SITE PLAN REVIEW FOR JUAN CARLOS MEZA (STEREOWORKZ) - APPROVED BY PLANNING DIRECTOR

SITE PLAN & 2 ARCHITECTURAL REVIEWS FOR LUCY MUNOZ SALON – APPROVED BY PLANNING DIRECTOR AND ARCHITECTURAL DESIGN REVIEW

Redlined Elevation Approval

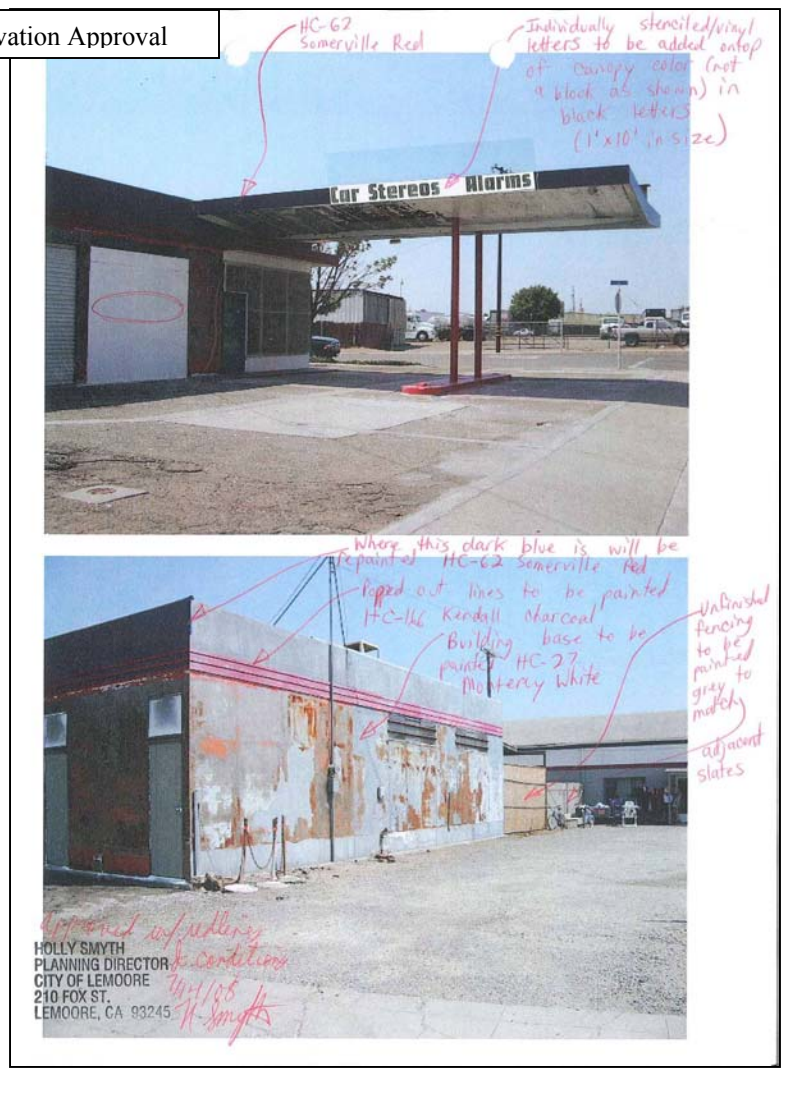
- Because the improvements being made to the site didn't change the façade and included painting the building in colors from the historic color palette, no

Redlined Site Plan Approval

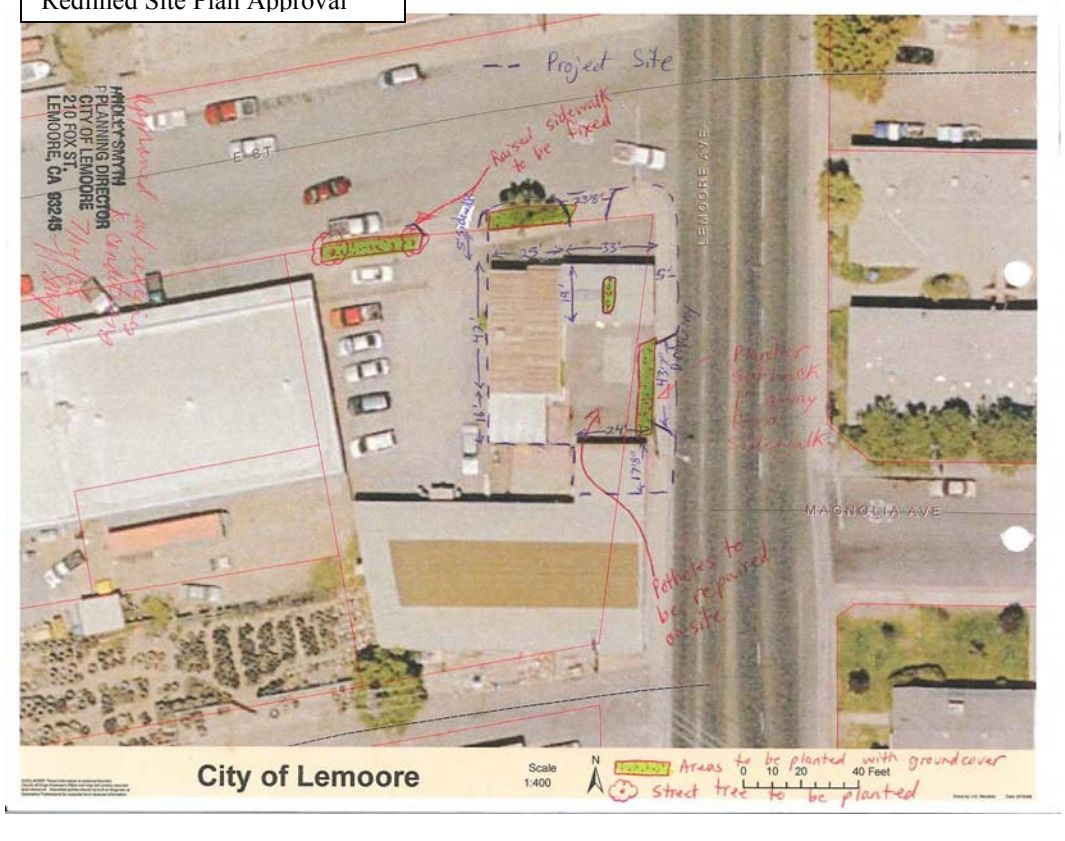
- Existing right-of-way (ROW) along the Lemoore Avenue site frontage appeared to be 60'. As discussed on the Popeye's example page, GP goal C-G-4 understands that there are some areas where existing land uses may constrain meeting City standards, which in this area would call for an 84-100' ROW. Because the existing onsite canopy and adjacent property building footprint are located directly behind the existing sidewalk within future ROW area, dedication requirements would be impossible to accommodate needed street widening without demolition of existing structures and therefore was not required. However, verbal discussions with Police Dept. wanted to limit ingress to the site from Lemoore Avenue to reduce traffic hazards; therefore planning director identified 3 different options that could help accomplish this either by 1) removing and replacing sidewalk with curb, or 2) installing gates, or 3) installing landscape. Due to below ground abatement of hazardous gases, new below ground landscaping is not allowed and above ground landscaped boxes were the preferred alternative by the property owner.

- Landscaping improvements came from GP policies CD-I-29, CD-I-24, CD-I-42 which required continued planting of street trees and landscape buffer along major arterials.

Redlined Site Plan Approval

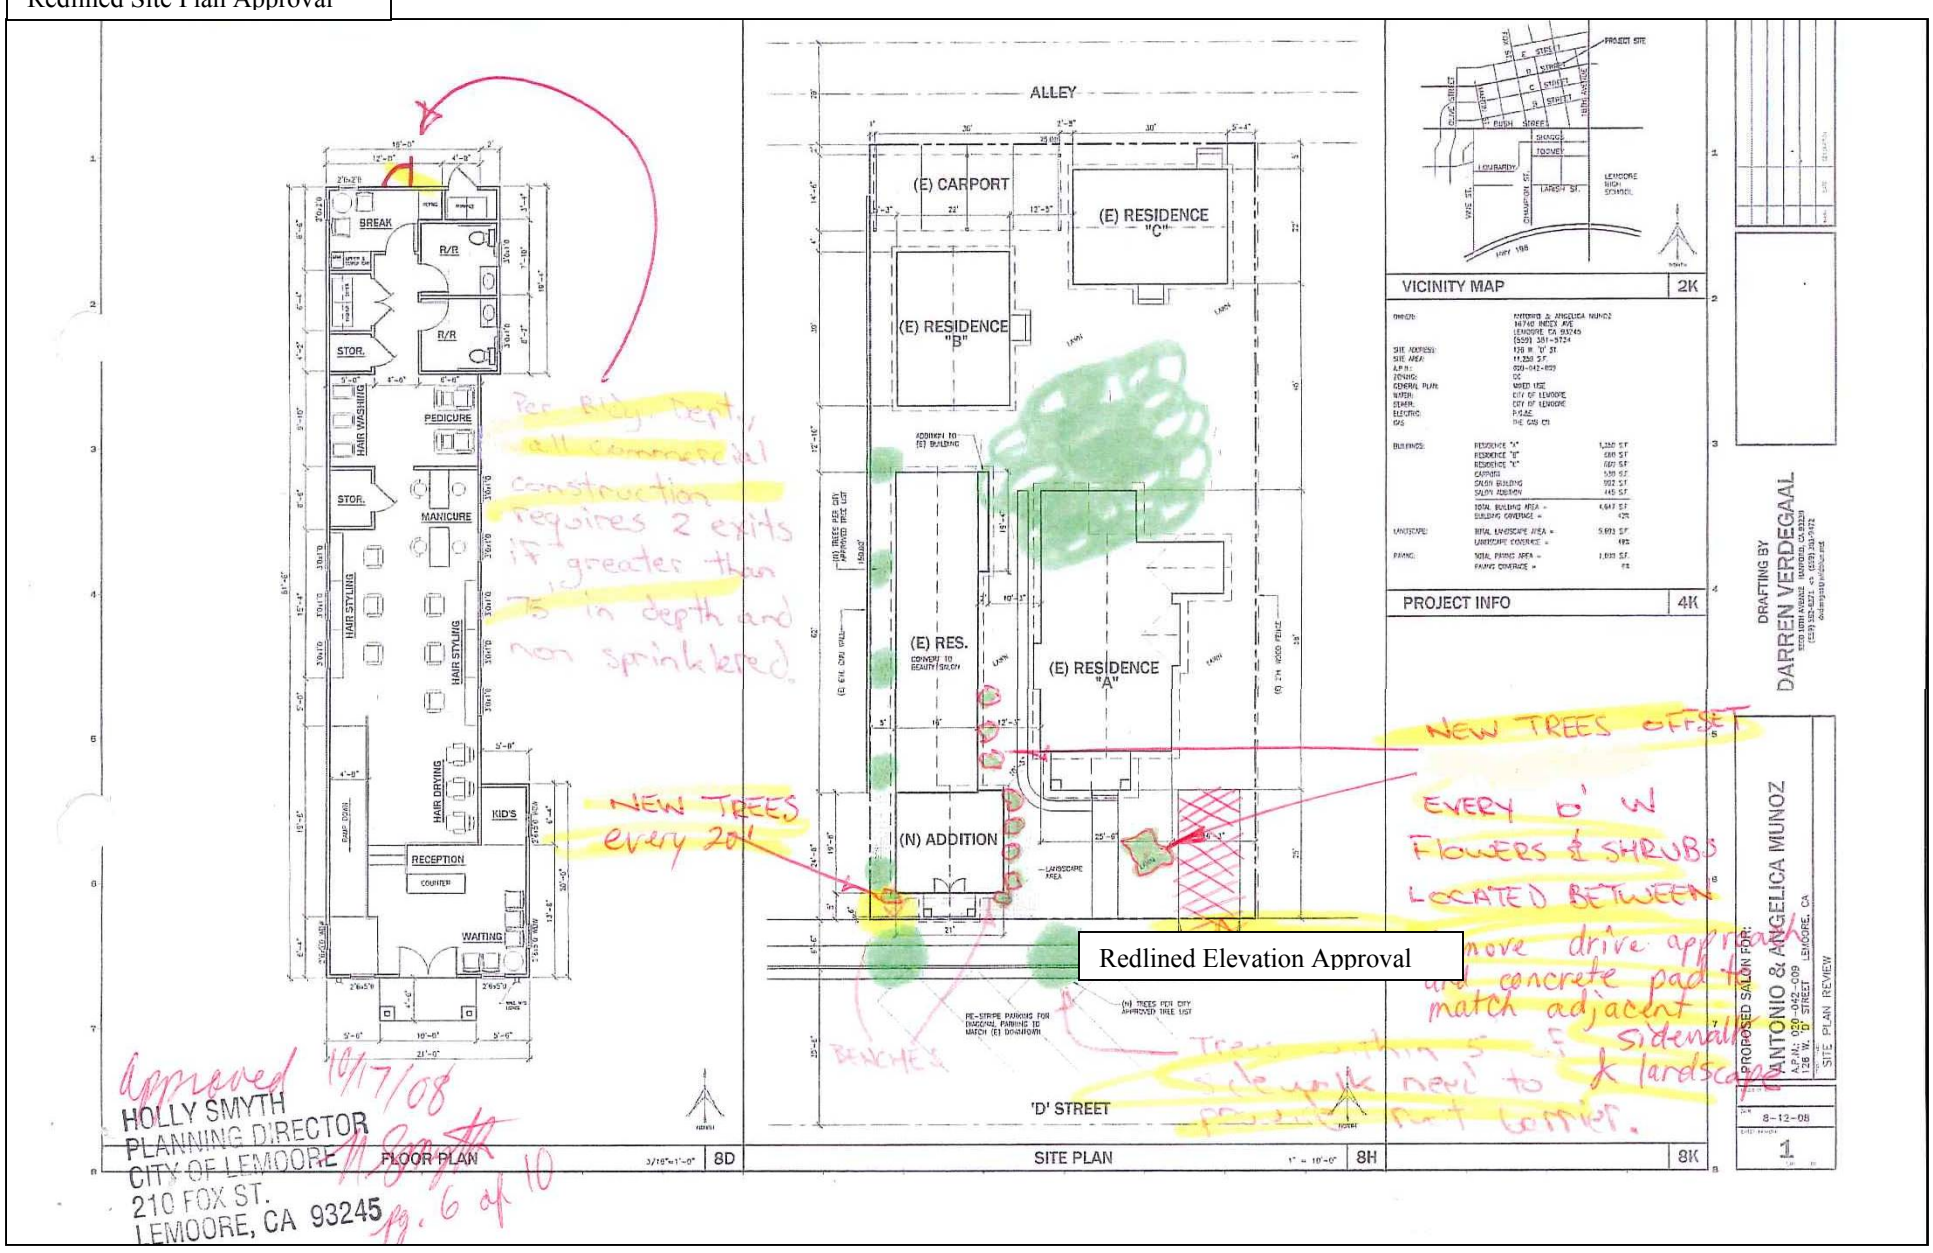
- Due to the existing structure and small addition no new on-site parking required but new striping in street would be incorporated to provide 4 angled parking stalls versus the 2 parallel spaces, however the drive approach to the other building on the same site would need to be removed, curb-cut removed and parkway installed.

2nd ADR Approved Redlined Revised Elevation Plans

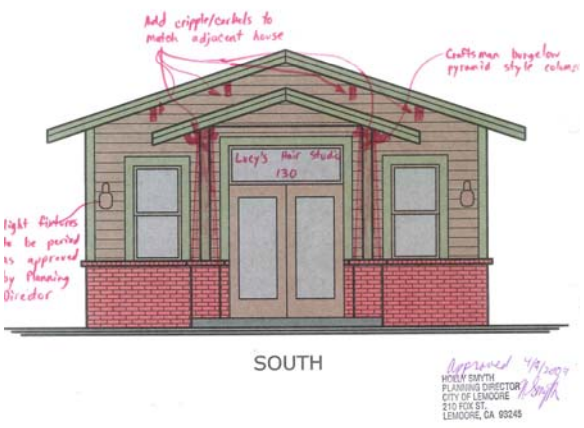
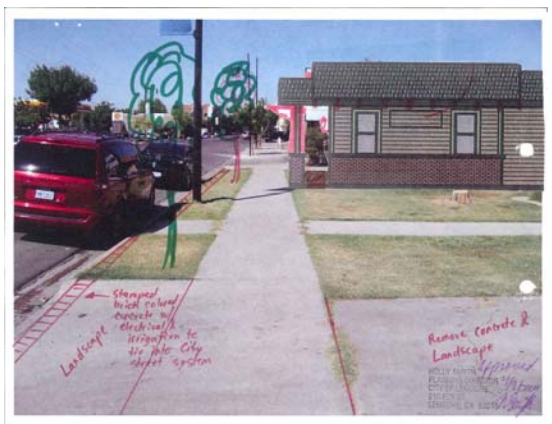
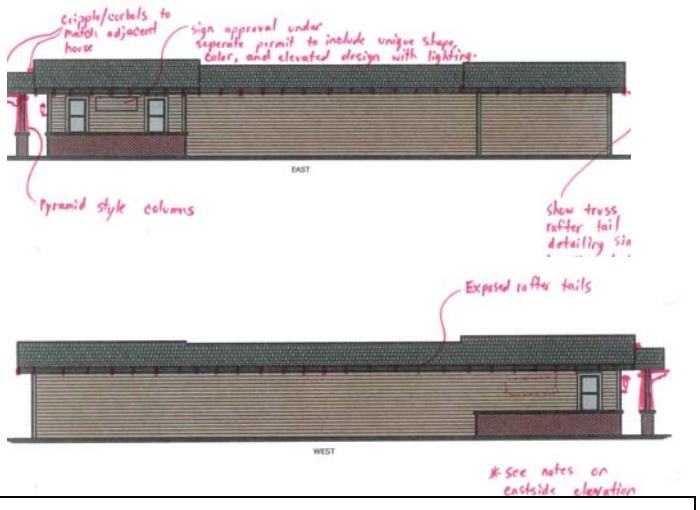
- New Building Plans were submitted to Bldg. Dept. for an entirely new building in place of the demolished building 3/3/2009
- Because new exterior elevations removed almost all exterior windows (since fire codes would not allow these windows to be operable and would save the applicant thousands of dollars), however new elevations were substantially different from ADR approval so 2nd review required. Application and fees submitted on 3/24/2009 and approved by ADR with modification on 4/9/2009.
